UNITED STATES PATENT AND TRADEMARK OFFICE

10/552,431

Office Action Summary	Application No. 10/552,431	Applicant(s) HANNEN ET AL.	
	Examiner GREGORY W. ADAMS	Art Unit 3652

DETAILED ACTION

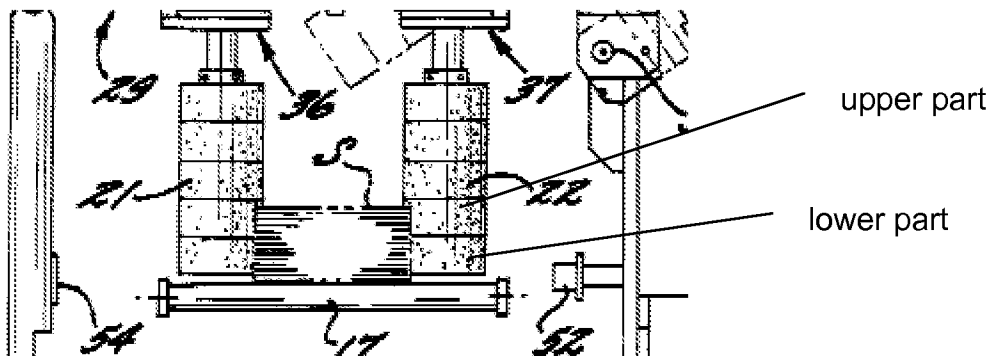
With respect to claim 17, Newsome et al. disclose an element having an upper and lower parts (see figure below.) Therefore, it would have been obvious to one having ordinary skill in the art at the time the invention was made to modify the apparatus of

Kaneda et al. to include upper and lower parts, as per the teachings of Newsome et al., to prevent damage during stack alignment.
